Product Change Notice (PCN)

PCN Number: **PCN-0451070R-02**

Product(s) Affected: **PJ-028-SMT-TR**

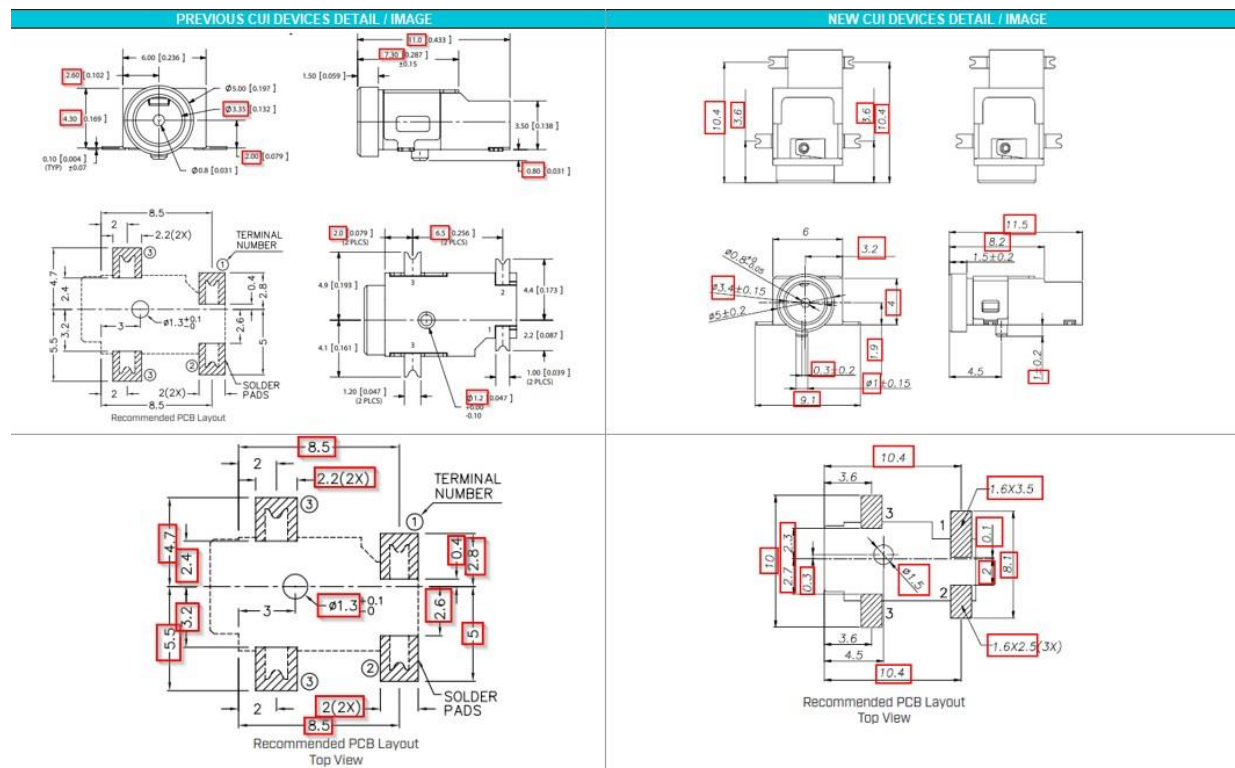
Description of Change: **Minor Housing and footprint differences. Material Change on the housing and terminals. See image Below**

PREVIOUS CUI DEVICES DETAIL / IMAGE	NEW CUI DEVICES DETAIL / IMAGE																																				
 <p>MATING PLUG Jack Insertion Depth: 7.0 mm</p>	 <p>MATING PLUG Jack Insertion Depth: 7.7 mm</p>																																				
<table border="1"> <thead> <tr> <th></th> <th>MATERIAL</th> <th>PLATING</th> </tr> </thead> <tbody> <tr> <td>center pin</td> <td>brass</td> <td>silver</td> </tr> <tr> <td>terminal 1</td> <td>brass</td> <td>silver</td> </tr> <tr> <td>terminal 2</td> <td>copper alloy</td> <td>silver</td> </tr> <tr> <td>terminal 3</td> <td>copper alloy</td> <td>silver</td> </tr> <tr> <td>plastic</td> <td>PA10T</td> <td></td> </tr> </tbody> </table>		MATERIAL	PLATING	center pin	brass	silver	terminal 1	brass	silver	terminal 2	copper alloy	silver	terminal 3	copper alloy	silver	plastic	PA10T		<table border="1"> <thead> <tr> <th>DESCRIPTION</th> <th>MATERIAL</th> <th>PLATING/COLOR</th> </tr> </thead> <tbody> <tr> <td>center pin</td> <td>brass</td> <td>gold</td> </tr> <tr> <td>terminal 1</td> <td>brass t=0.20</td> <td>gold</td> </tr> <tr> <td>terminal 2</td> <td>phosphor bronze t=0.25</td> <td>gold</td> </tr> <tr> <td>terminal 3</td> <td>phosphor bronze t=0.20</td> <td>gold</td> </tr> <tr> <td>housing</td> <td>PA9T (UL94V-0)</td> <td>black</td> </tr> </tbody> </table>	DESCRIPTION	MATERIAL	PLATING/COLOR	center pin	brass	gold	terminal 1	brass t=0.20	gold	terminal 2	phosphor bronze t=0.25	gold	terminal 3	phosphor bronze t=0.20	gold	housing	PA9T (UL94V-0)	black

MATERIAL	PLATING																																			
center pin	brass	silver																																			
terminal 1	brass	silver																																			
terminal 2	copper alloy	silver																																			
terminal 3	copper alloy	silver																																			
plastic	PA10T																																				
DESCRIPTION	MATERIAL	PLATING/COLOR																																			
center pin	brass	gold																																			
terminal 1	brass t=0.20	gold																																			
terminal 2	phosphor bronze t=0.25	gold																																			
terminal 3	phosphor bronze t=0.20	gold																																			
housing	PA9T (UL94V-0)	black
